## APPEAL SUMMARY

**Status:** Decision Rendered**Appeal ID:** 15833**Project Address:** 817 SW 17th Ave**Hearing Date:** 9/13/17**Appellant Name:** Michelle Schulz**Case No.:** B-016**Appellant Phone:** 503-548-2379**Appeal Type:** Building**Plans Examiner/Inspector:** Kathy Aulwes**Project Type:** commercial**Stories:** 9 **Occupancy:** B, M, A **Construction Type:** 1-B**Building/Business Name:** Press Blocks - Half Block Office**Fire Sprinklers:** Yes - Throughout**Appeal Involves:** Erection of a new structure**LUR or Permit Application No.:** 17-182179-CO**Plan Submitted Option:** pdf [File 1] [File 2] [File 3]**Proposed use:** Office with ground level retail

Opening Protectives  
Appeal

EXHIBIT A-2

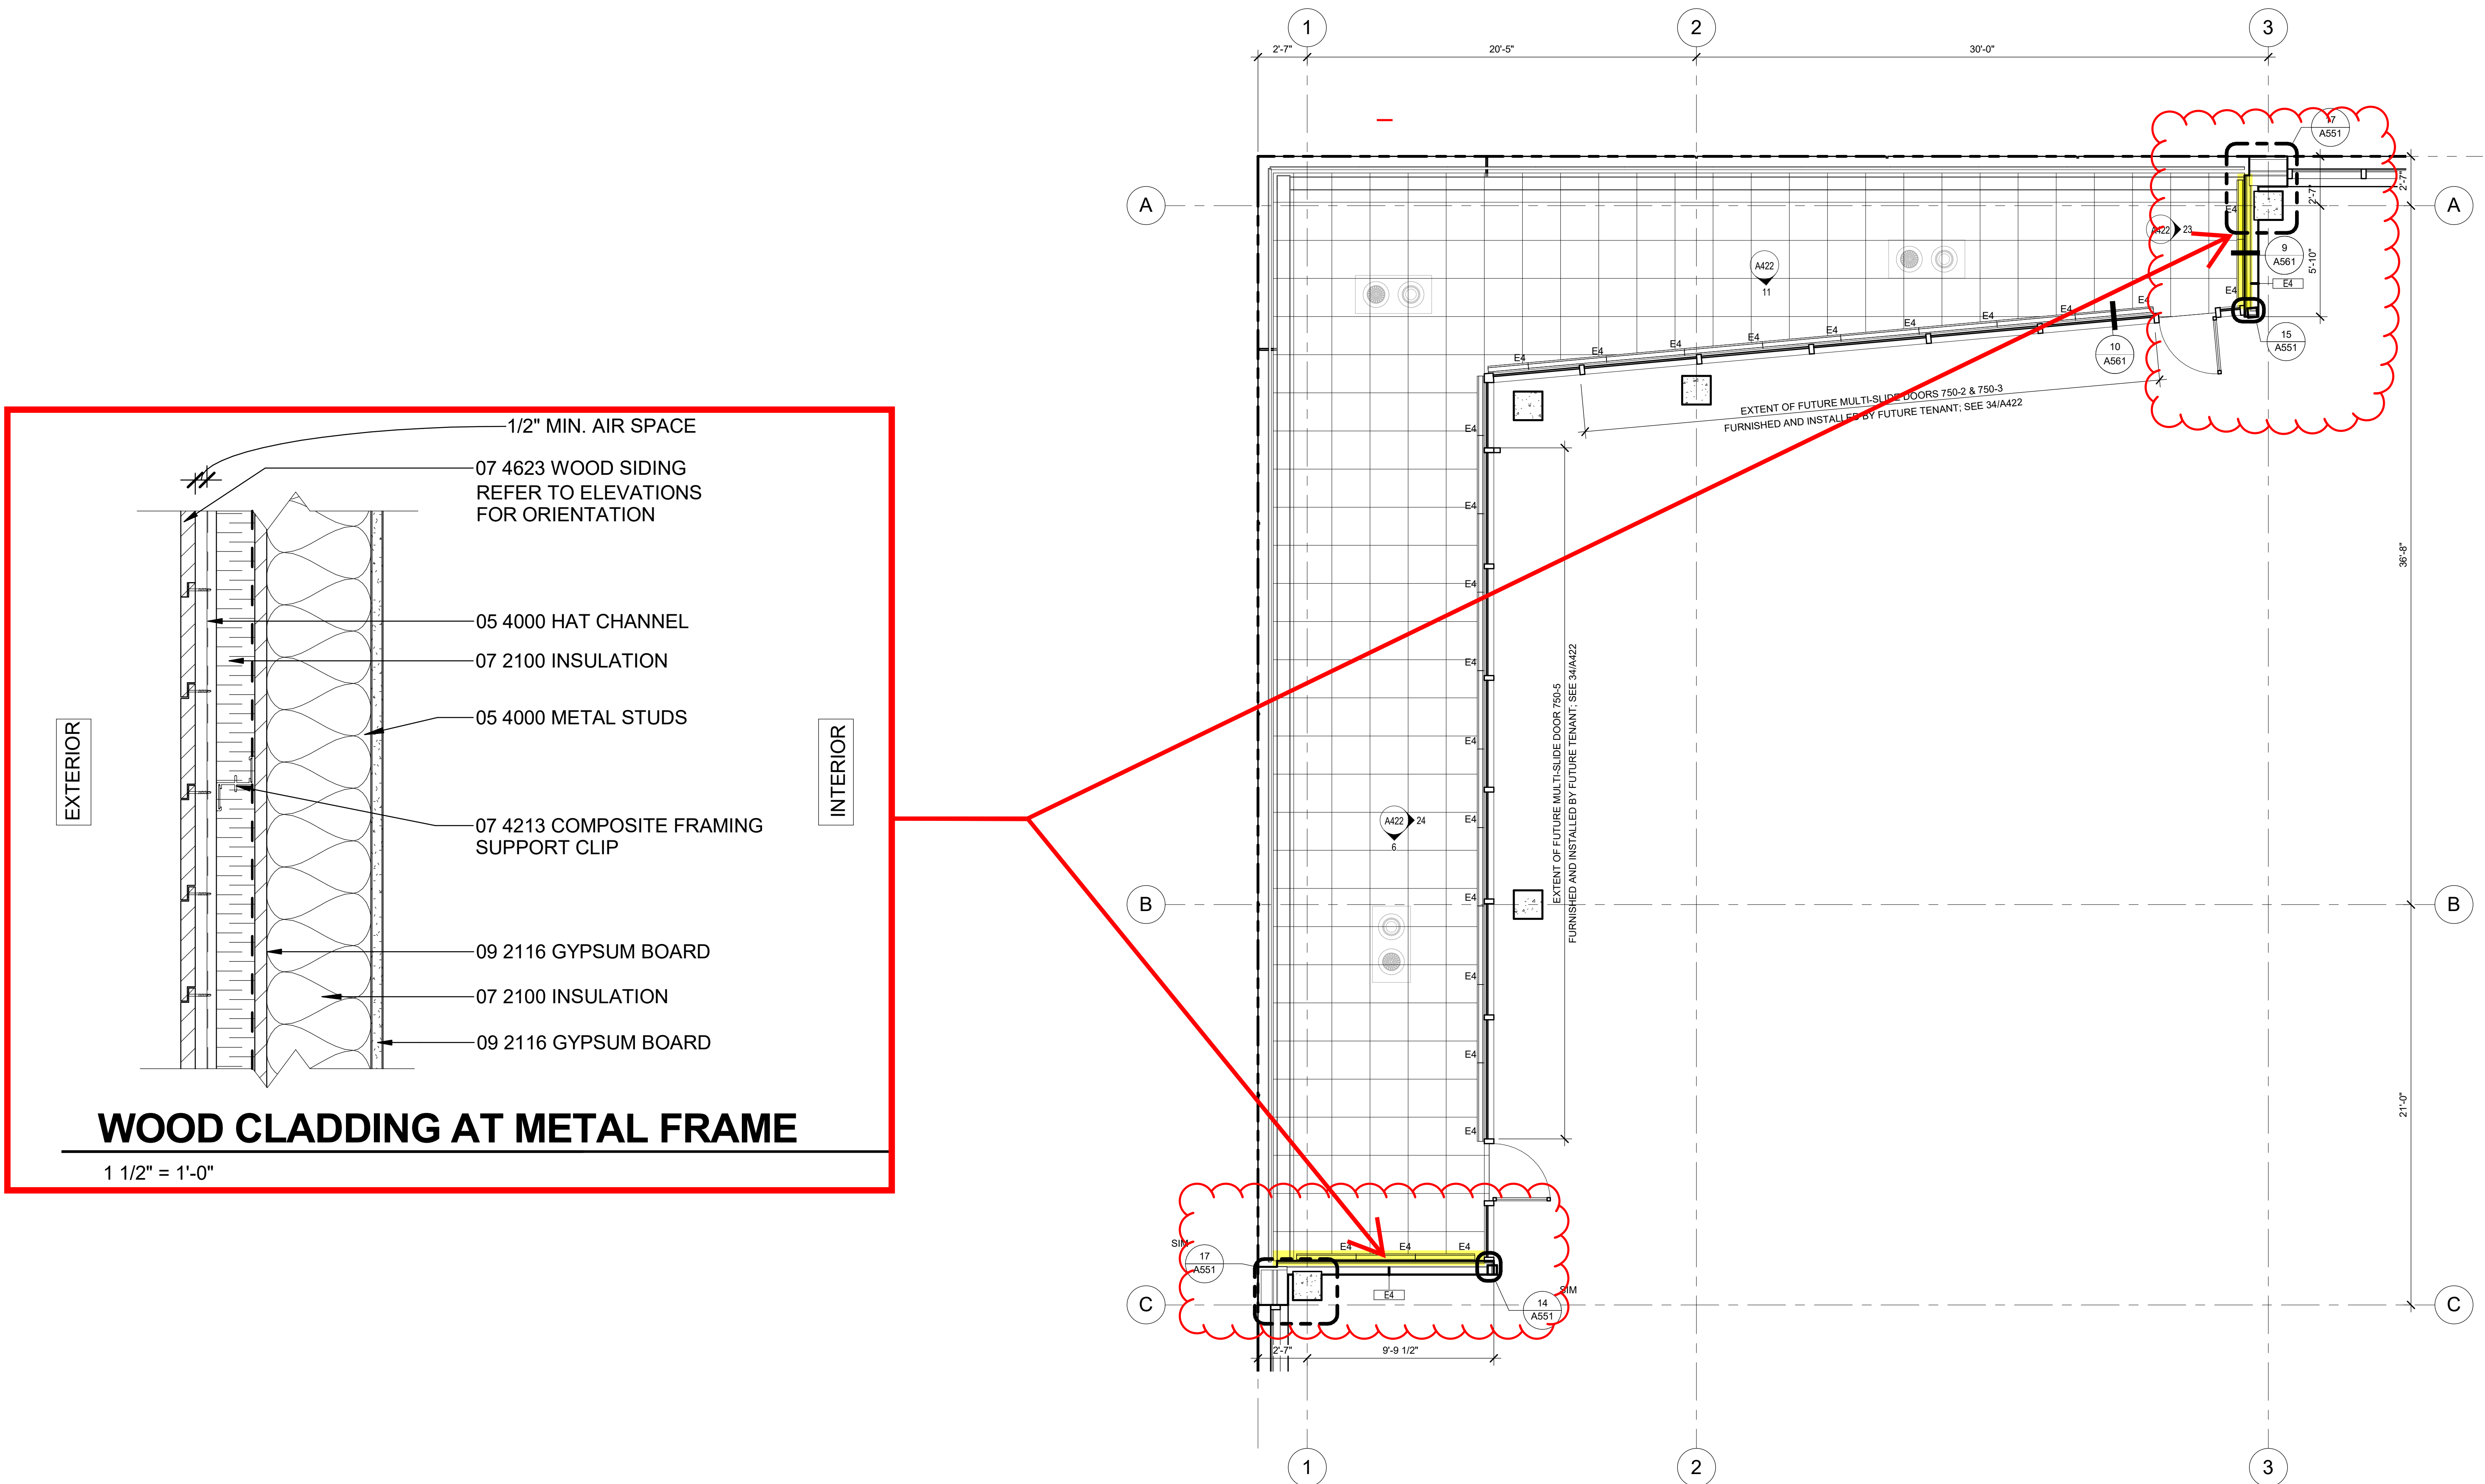
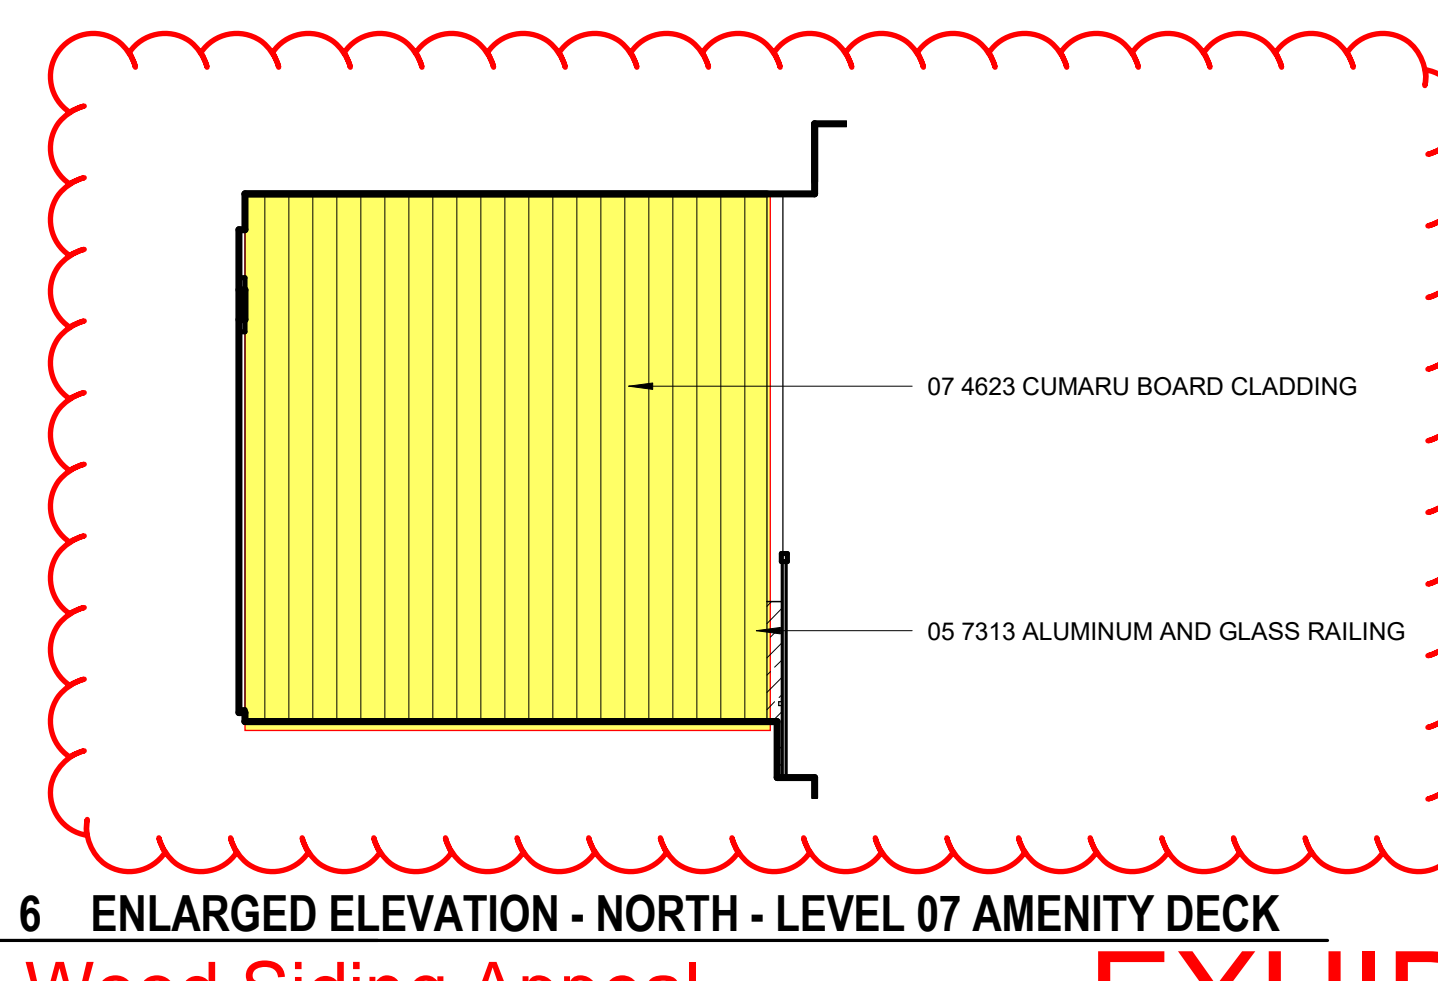
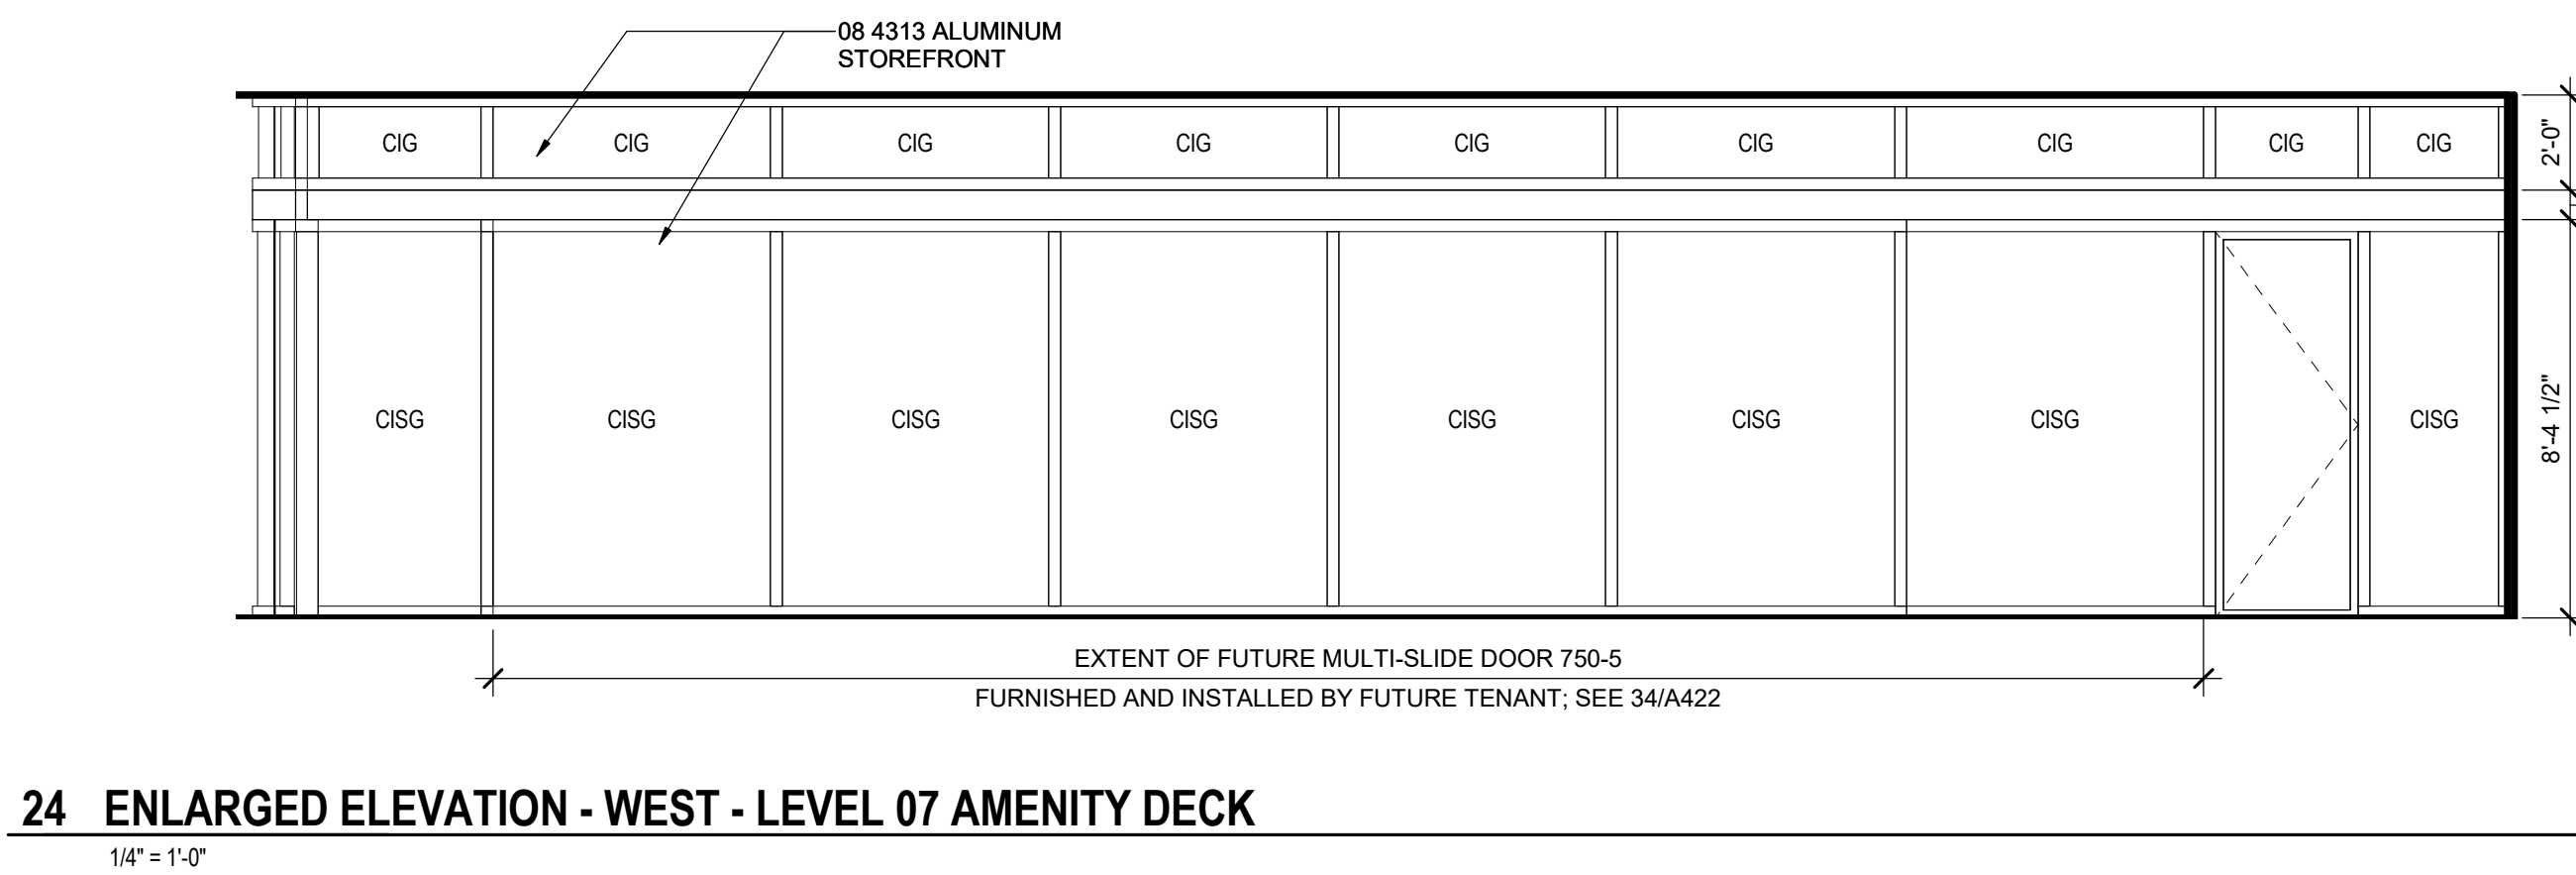
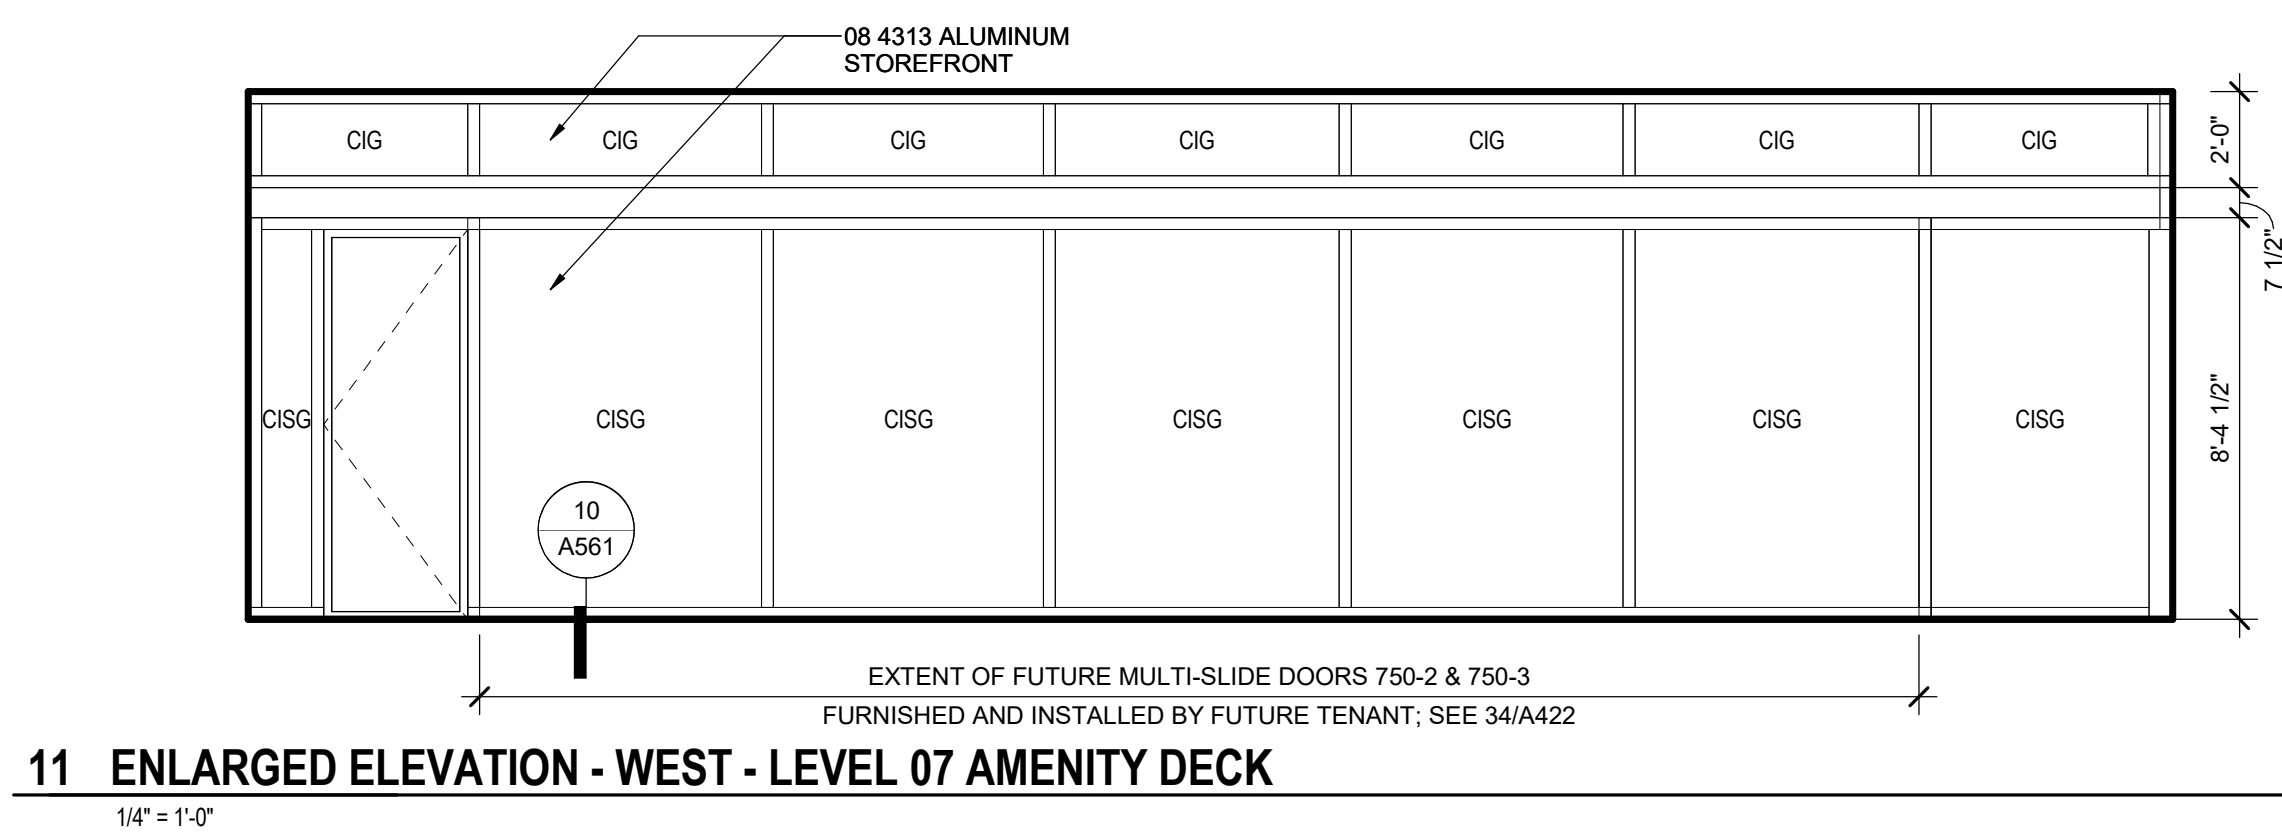
**Proposed Design** The proposed design utilizes FSC certified 1x6 tropical hardwood (Cumaru) as exterior siding at one location on the 7th floor at an exterior terrace. The total area of wood is approximately 199 SF. The wood siding is mounted on fiberglass or galvanized steel Z- furring which is mounted on one layer of exterior gypsum sheathing (Densglass or equivalent) to form a rainscreen. Mineral wool takes up a 2" of a 2 ½" cavity behind the wood siding. The exterior wall assembly is non-combustible throughout.

**3. Cumaru tropical wood Class A cladding at exterior 7th floor amenity space: Granted provided open flame devices are located with a minimum of ten feet separation from the wood cladding.**
